**LEGAL ADVERTISEMENT  
PORTLAND PLANNING BOARD  
MEETING AGENDA**

**To:** Chair Boepple and Members of the Portland Planning Board  
**From:** Matthew Grooms, Planner  
**Date:** October 5, 2017  
**Re:** Brandy Lane Subdivision (Sixteen Lots), 22 Hope Lane  
LBW, LLC  
Preliminary Review  
**Project #:** 2017-117 **CBL:** 448-A-004  
**Meeting Date:** October 10, 2017

RE: Staff Review Comments for Brandy Lane Subdivision (2017-117) – Planning Board Review

**TO:** Matt Grooms, Planner  
**FROM:** Lauren Swett, PE & Craig Sweet, EIT  
**DATE:** September 14, 2017  
**RE:** Brandy Lane, Subdivision Application

C102

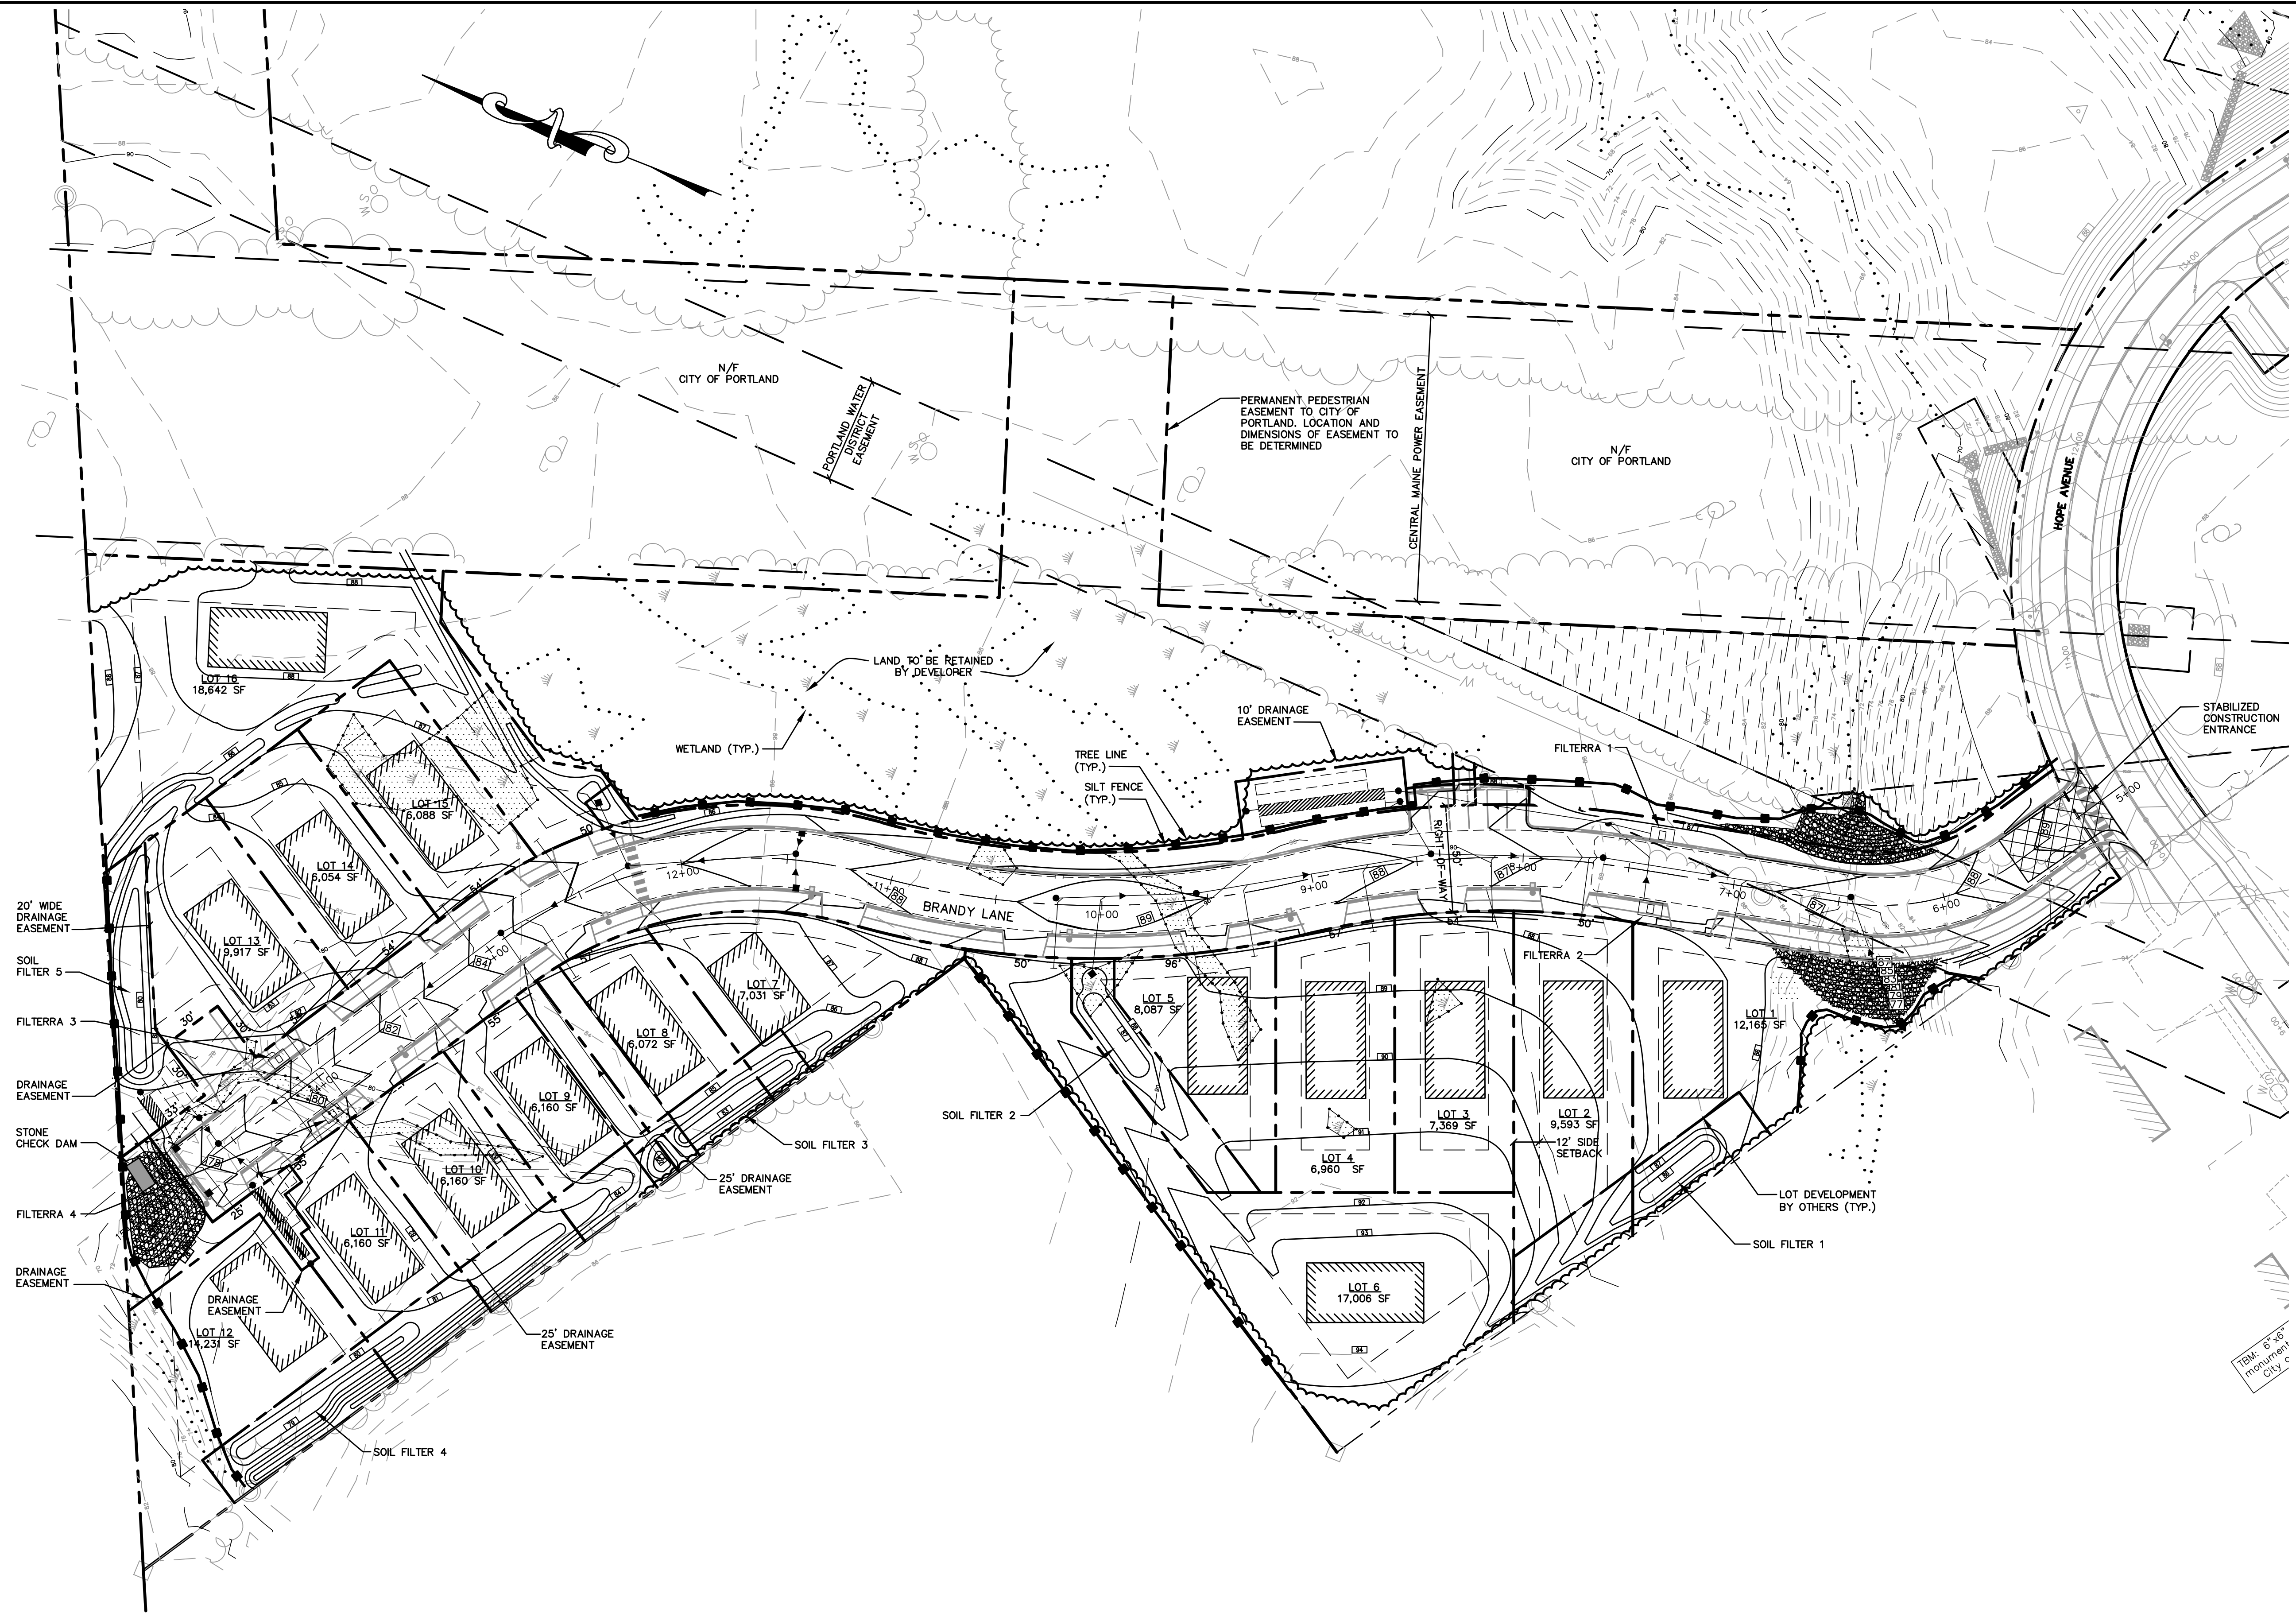
**Sheet C101 & C102:**

##### **Sheet C101 & C102**

**Response:** The locations of proposed manhole covers is in accordance with Figure I-4 from the City's Technical Manual. Manhole structures have been located outside of axle tracking to the best extent practical.
